# Access Compliance Report

### (Curb Ramps)

Intersection ID: 10034320	Main Street: PERIMETER_PY	Cross Street: N/A	Location: SE
ADA ID: 8404F6353AF9	Ramp Type: Perp	Initial Pass/Fail: Fail	Overall Compliance: No
Severity Score: 1.25			
Codes/Mitigation Info/Possible Solution		Field Measurements/Component Compliance

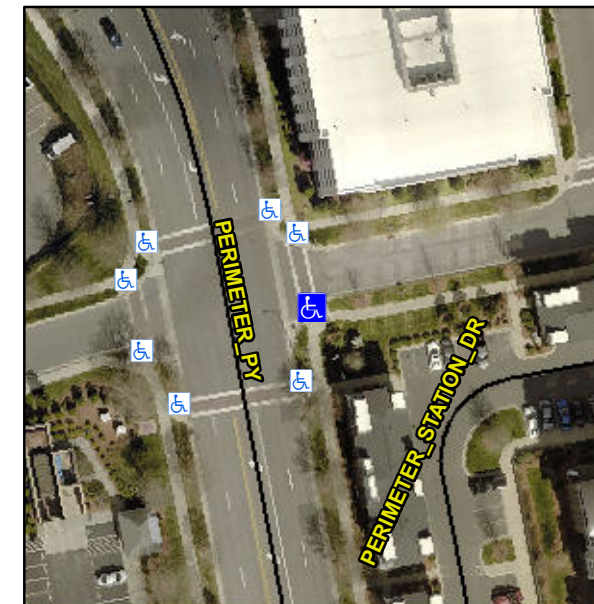
**Not Found, R304.5.3**

Compliance	Description	Data	Compliance	Description	Data
N/A	Ramp Length (in)	48.0	Yes	Ramp Slope (%)	5.5
Yes	Ramp Width (in)	48.0	No	Ramp XSlope (%)	3.6
N/A	Flare Type LT	N/A	N/A	Flare Type RT	N/A
N/A	Flare Slope LT (%)	N/A	N/A	Flare Slope RT (%)	N/A
N/A	Flare Traversable LT?	N/A	N/A	Flare Traversable RT?	N/A
N/A	Landing Length (in)	N/A	N/A	DWS Provided?	N/A
N/A	Landing Width (in)	N/A	N/A	DWS Contrast?	N/A
N/A	Landing Slope (%)	N/A	N/A	DWS Length (in)	N/A
N/A	Landing X Slope (%)	N/A	N/A	DWS Full Width?	N/A
N/A	Landing Curb? (Y/N)	N/A	N/A	DWS Offset (in)	N/A
N/A	Shared Landing?	N/A			
N/A	Gutter Ponding?	N/A	N/A	Gutter Slope (%)	N/A
N/A	Gutter Lip Ht (in)	N/A	N/A	Gutter X Slope (%)	N/A
N/A	Painted X Walk1?	Yes	N/A	Painted X Walk2?	N/A
	X Walk 1 Direction	To N		X Walk 2 Direction	N/A
N/A	X Walk 1 Width (in)	72.0	N/A	X Walk 2 Width (in)	N/A
	X Walk 1 Slope (%)	6.1		X Walk 2 Slope (%)	N/A
	X Walk 1 X Slope (%)	0.5		X Walk 2 X Slope (%)	N/A

**Remove & Replace Entire Ramp.**
